18/08-04B 15130 Barnesville Road  
Boys Historic District

SUBJECT: Historic Area Work Permit Application – Approval

TO: Robert Hubbard, Director  
FROM: Gwen Wright, Coordinator *GW*  
Historic Preservation  
SUBJECT: Historic Area Work Permit

# APPLICATION FOR HISTORIC AREA WORK PERMIT

15130 + 15134 BARNESVILLE ROAD  
TREE REMOVAL

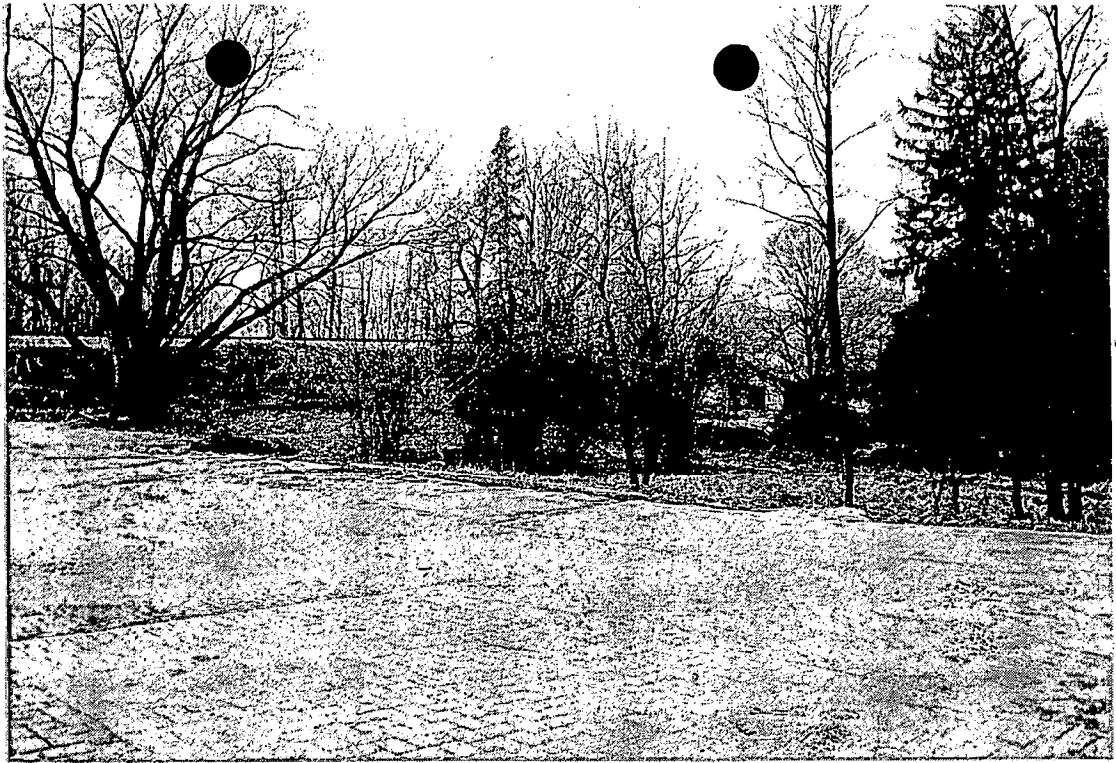
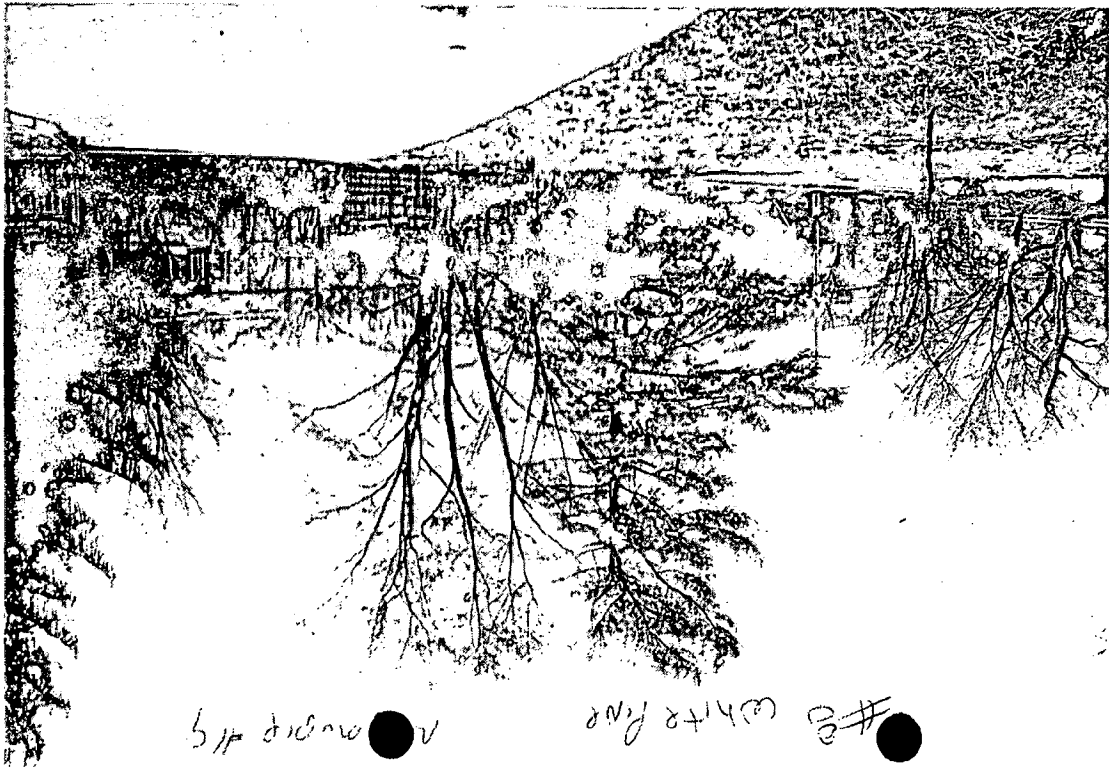
#6. HUGE SILVER MAPLE - REMOVE  
LONG TERM HEALTH CONCERN

#7 50" RED MAPLE. ENTIRE TREE  
SHOULD BE TAKEN DOWN

② THE LARGE SILVER MAPLE TREE SHOULD NOT BE REMOVED

BT THIS TIME. THE APPLICANT SHOULD WORK WITH AN ARBORIST ON RESTORATIVE MEASURES, SUCH AS FERTILIZATION AND AERATION,  
and HPC staff will review and stamp the construction drawings prior to the applicant's applying for a building permit with DPS; and *SO THAT THE TREE CAN REMAIN HEALTHY.*
